Service Bulletin

Fuselage - Primary Structure, Center-Mid Fuselage - Routing Modification of the VFG Power-Feeder Harnesses

BD500-534101
Issue No. 008

Fuselage - Primary Structure, Center-Mid Fuselage - Routing Modification of the VFG Power-Feeder Harnesses - Service Bulletin

Figure 3 Left side - Routing modification of the power-feeder harnesses - Installation - (Sheet 1 of 2)

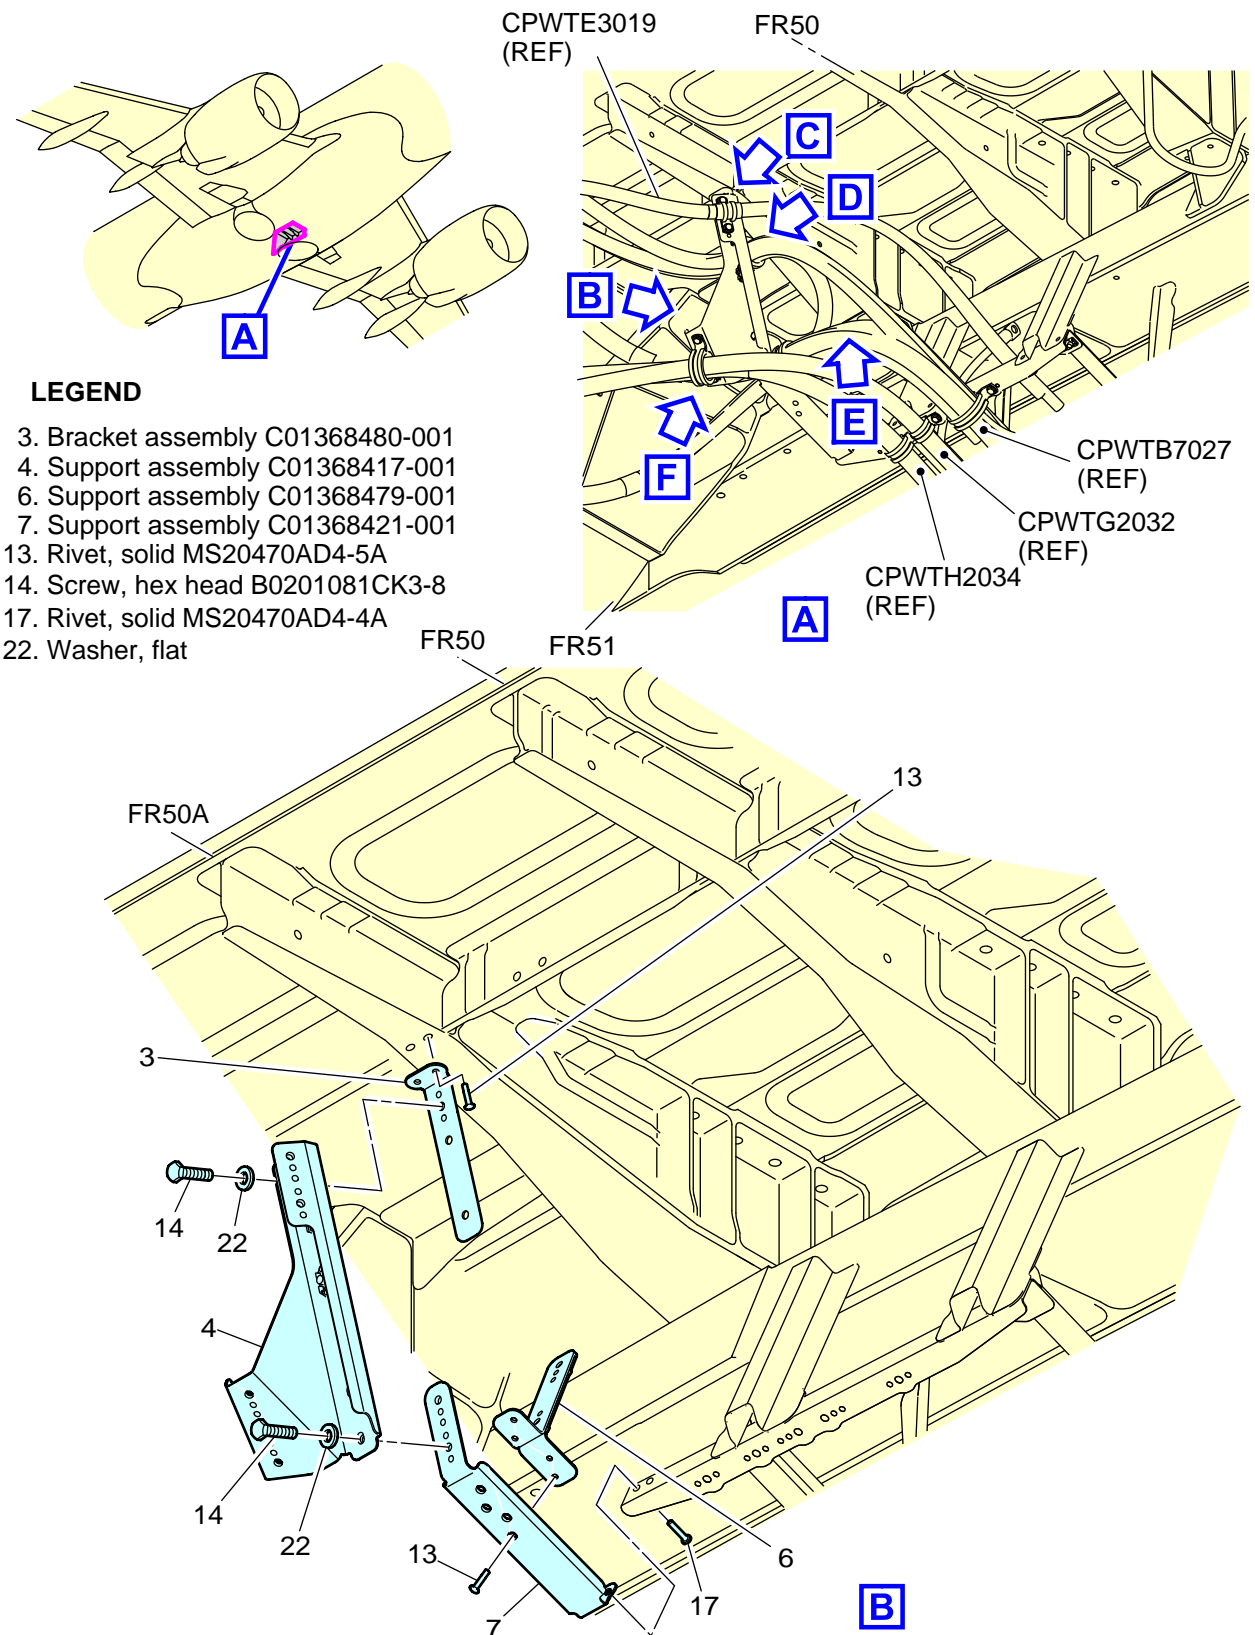
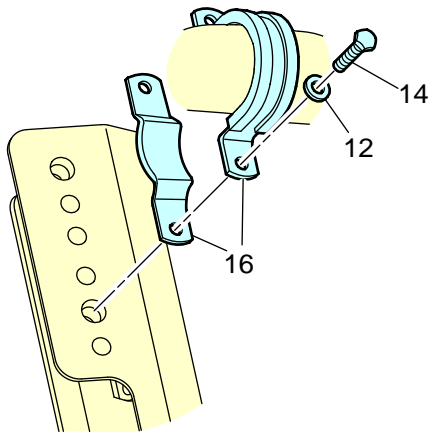
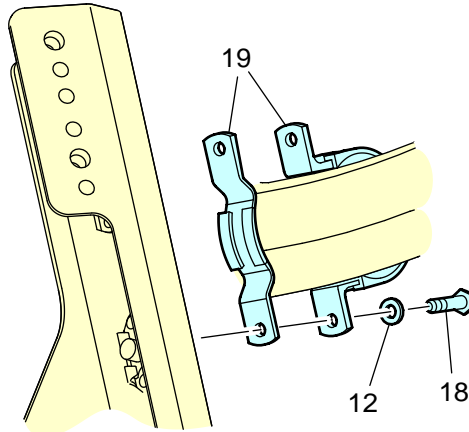
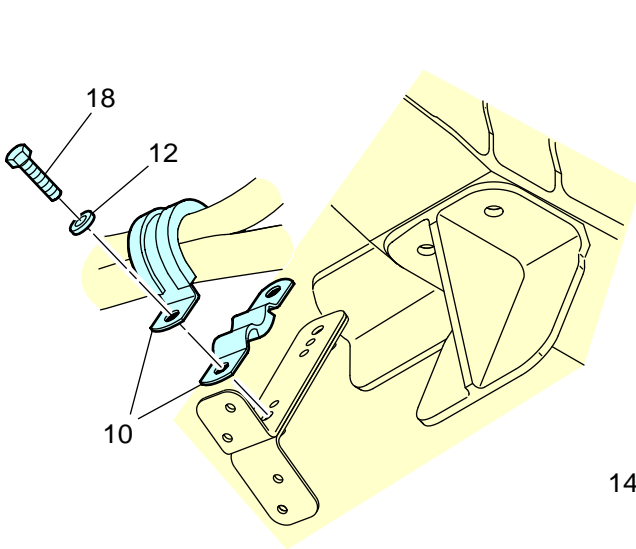
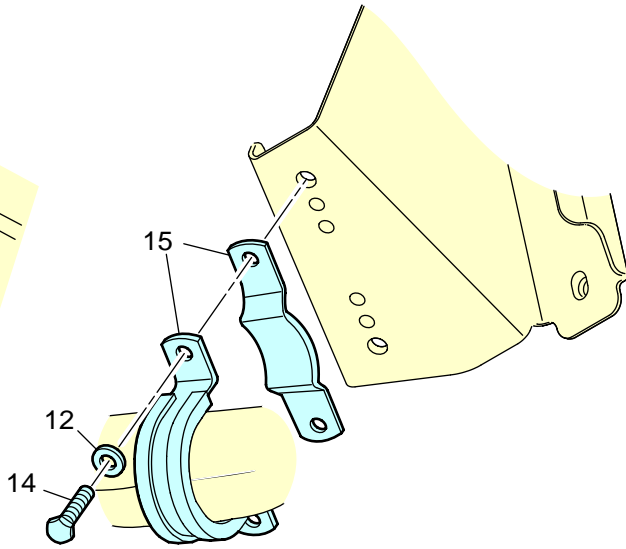
3.4.1.3 Remove the electrical system bracket assembly (3).

3.4.1.4 Remove burrs and sharp edges on the electrical system bracket assembly (3) and FR50A.

3.4.2.3 Remove the electrical system support assembly (7).

3.4.2.4 Remove burrs and sharp edges on the electrical system support (7) and the electrical system bracket installation.

3.4.2.5 Wet-install with sealant the electrical system support assembly (7) on FR50A with two rivets (17) wet with sealant (refer to ASRP BD500-A-J51-42-06-00AAA-078A-A and ASRP BD500-A-J51-23-00-05AAA-259B-A).

-
- 3.4.2.6 Apply a layer of fluid-resistant polyurethane topcoat to the rivets (17) to agree with the color of the adjacent area (refer to ASRP BD500-A-J51-25-16-00AAA-257A-A).

- 3.4.3 Install the electrical system support assembly (6) as follows:
 - 3.4.3.1 Temporarily install the electrical system support assembly (6) in the pilot holes on the support assembly (7).

- 3.4.3.3 Remove the electrical system support assembly (6).
 - 3.4.3.4 Remove burrs and sharp edges on the electrical system support assembly (6).
 - 3.4.3.5 Wet-install with sealant the electrical system support assembly (6) on the support assembly (7) with four rivets (13) (refer to ASRP BD500-A-J51-42-06-00AAA-078A-A and ASRP BD500-A-J51-23-00-05AAA-259B-A).

Figure 4 Right side - Routing modification of the power-feeder harnesses - Removal - (Sheet 1 of 2)

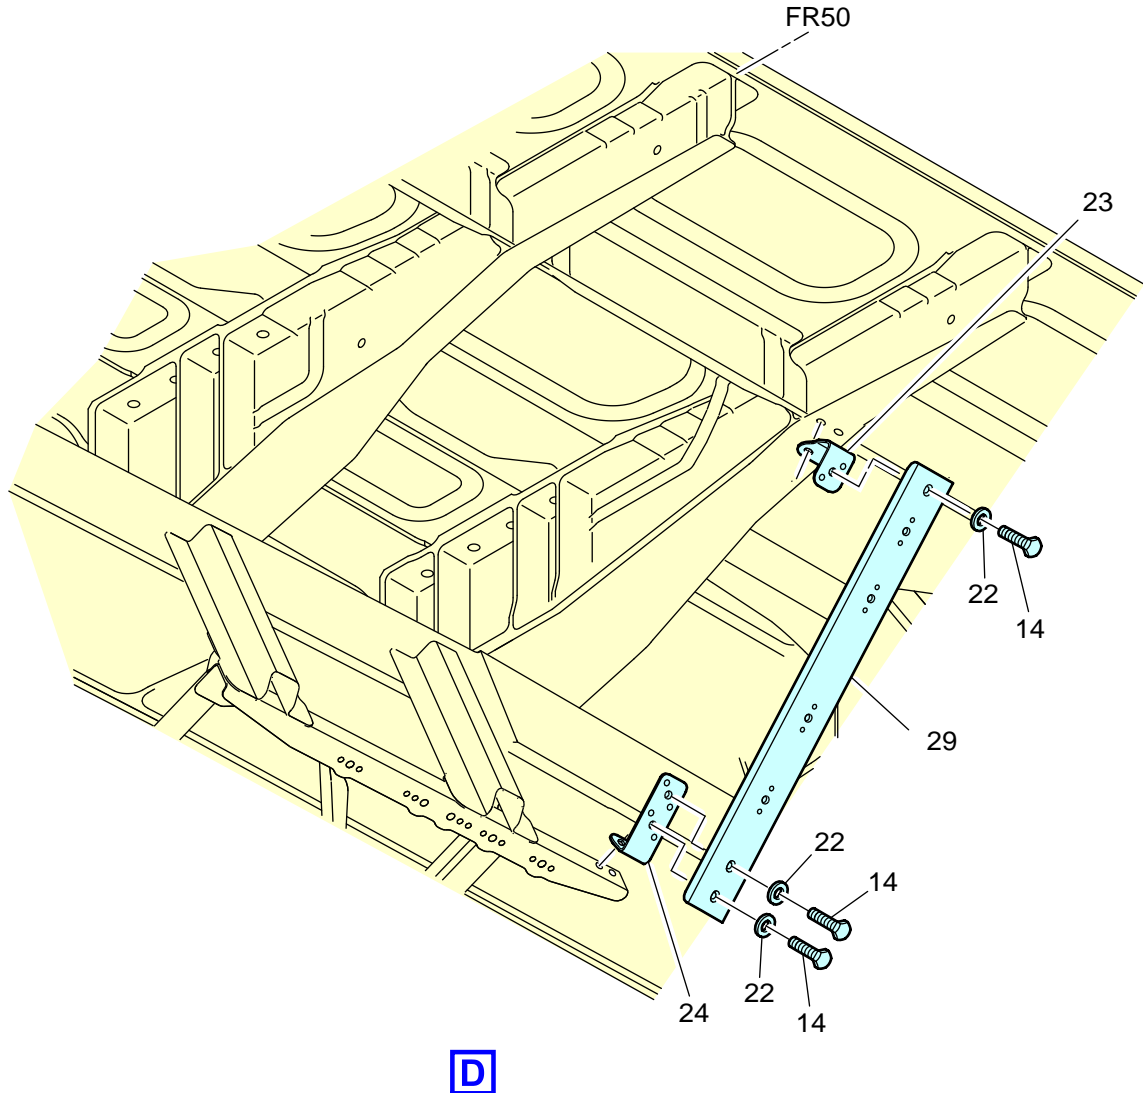
- 3.5.1 Remove the saddle clamp (10), screws (2), and washers (12) that hold the harness CPYTB7034.
- 3.5.2 Discard the screws (2). Keep the clamp (10) and the washers (12).
- 3.5.3 Remove the saddle clamp (27), clamp (28), two screws (26), and two washers (12) that hold the harness CPWTB7027.
- 3.5.4 Discard the two screws (26). Keep the saddle clamp (27), clamp (28), and two washers (12).
- 3.5.5 Remove the electrical system support assembly (29), screws (14), and the washers (22).
- 3.5.6 Discard the electrical system support assembly (29). Keep the screws (14) and the washers (22).
- 3.5.7 Remove and discard the two electrical system brackets assemblies (23) and (24) (refer to ASRP BD500-A-J51-42-06-00AAA-078A-A).

Figure 5 Right side - Routing modification of the power-feeder harnesses - Removal - (Sheet 1 of 2)

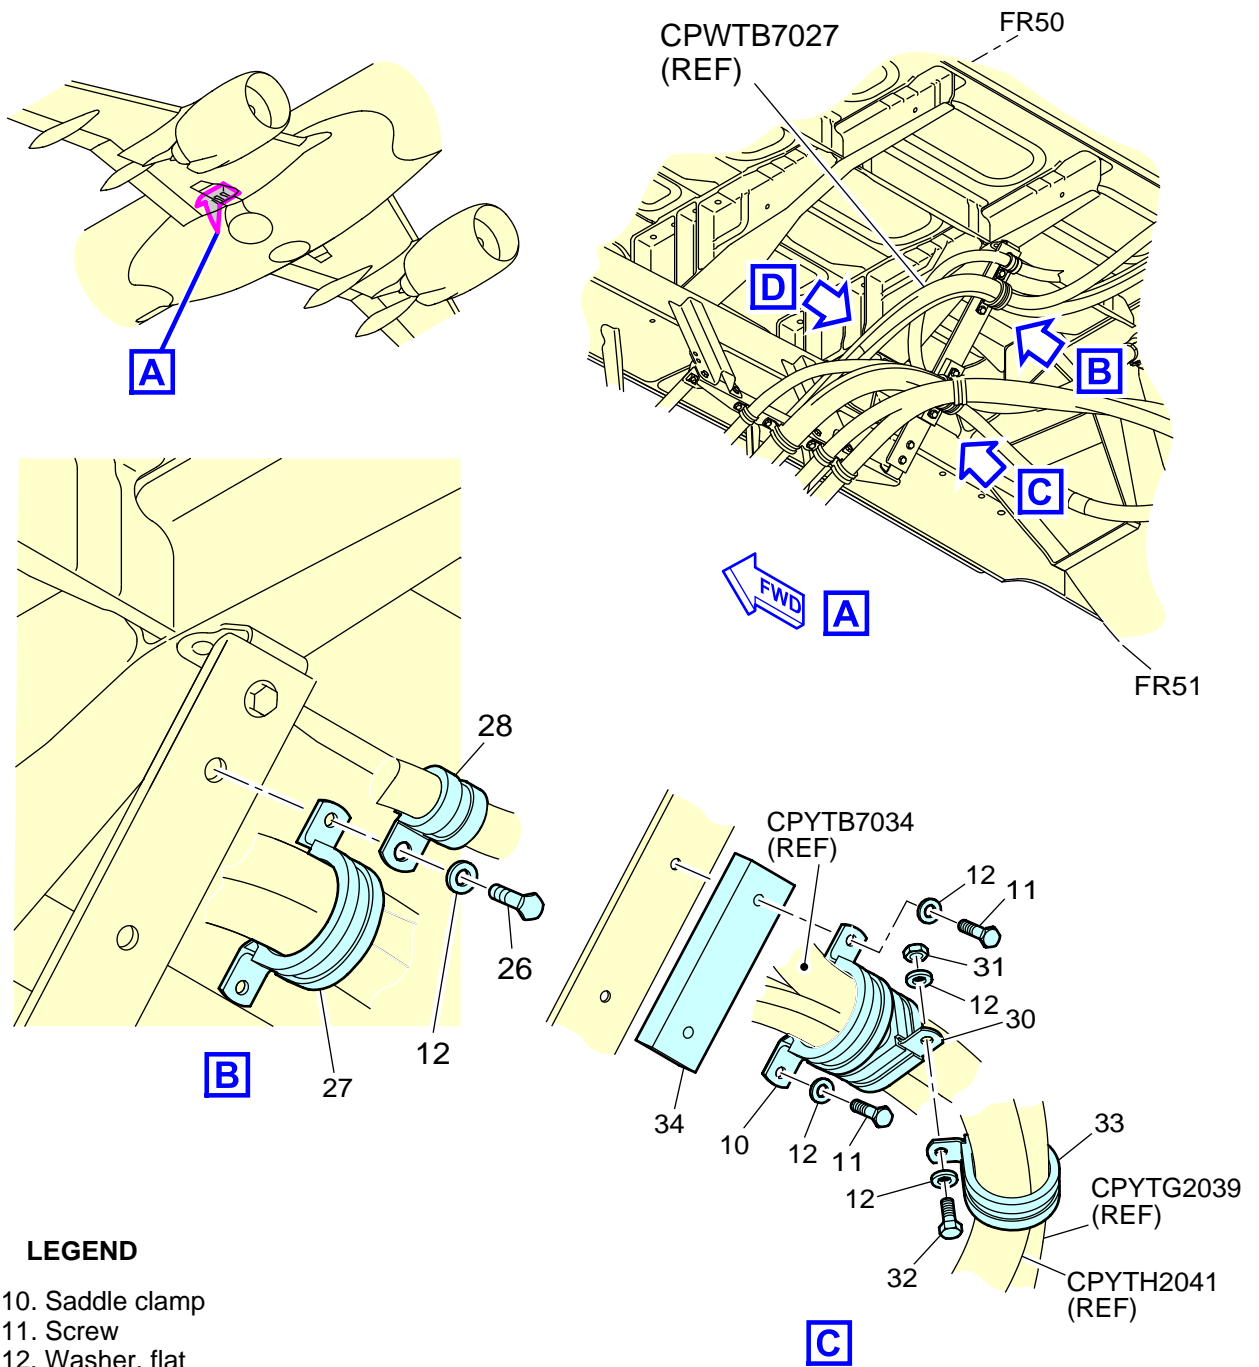
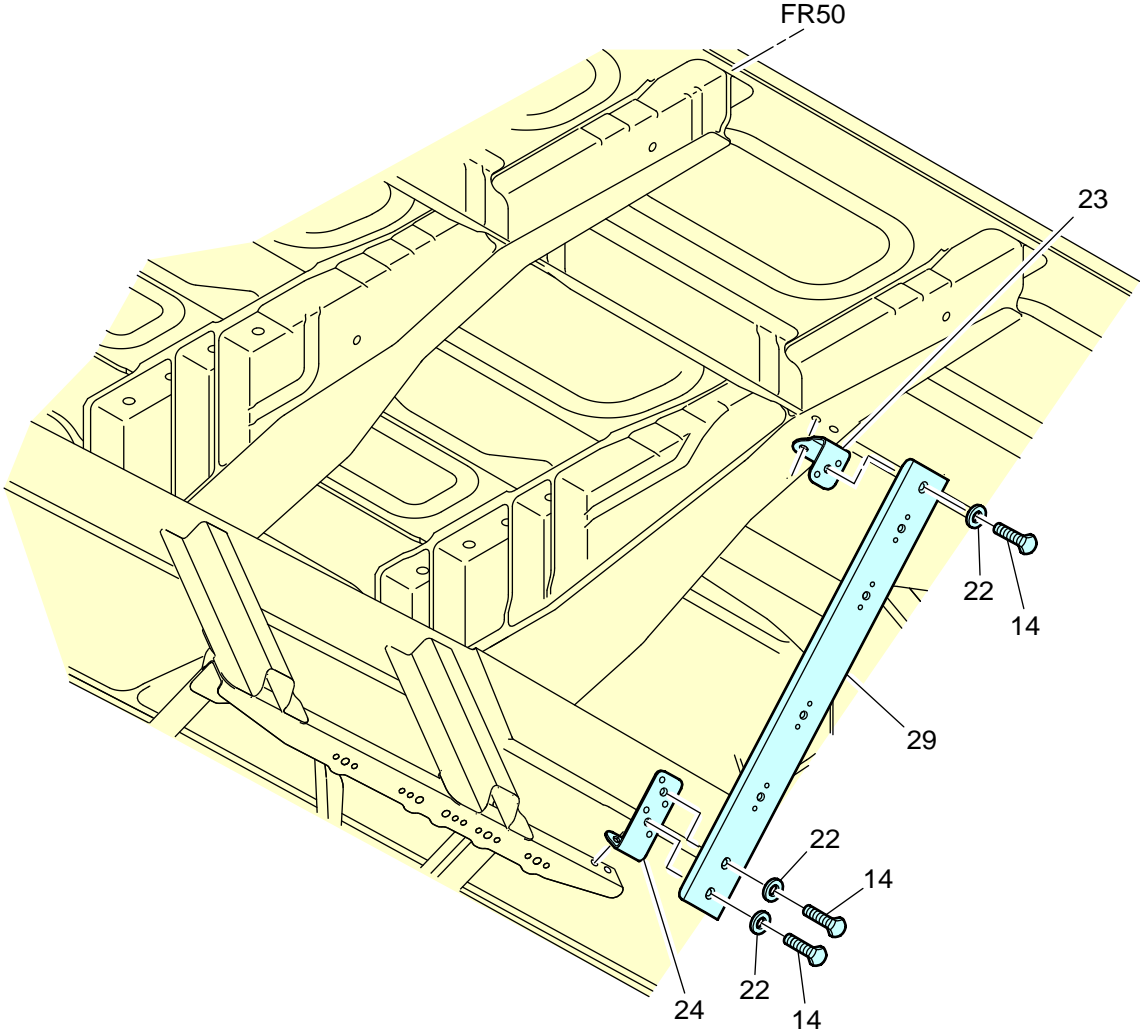
- 3.6.1 Remove the clamp (30), clamp (33), nut (31), screw (32), and washers (12) that hold the harnesses CPYTG2039 and CPYTH2041.
- 3.6.2 Discard the clamp (30), clamp (33), nut (31), and screw (32). Keep the washers (12).

- 3.6.3 Remove the saddle clamp (10), screws (11), packer (34), and washers (12) that hold the harness CPYTB7034.
- 3.6.4 Discard the screws (11) and the packer (34). Keep the saddle clamp (10) and washers (12).

- 3.6.5 Remove the saddle clamp (27), saddle clamp (28), two screws (26), and two washers (12) that hold the harness CPWTB7027.
- 3.6.6 Discard the two screws (26). Keep the saddle clamp (27), saddle clamp (28), and two washers (12)

- 3.6.7 Remove the electrical system support assembly (29), screws (14), and washers (22).
- 3.6.8 Discard the electrical system support assembly (29). Keep the screws (14) and the washers (22).

- 3.6.9 Remove and discard the two electrical system brackets assemblies (23) and (24) (refer to ASRP BD500-A-J51-42-06-00AAA-078A-A).
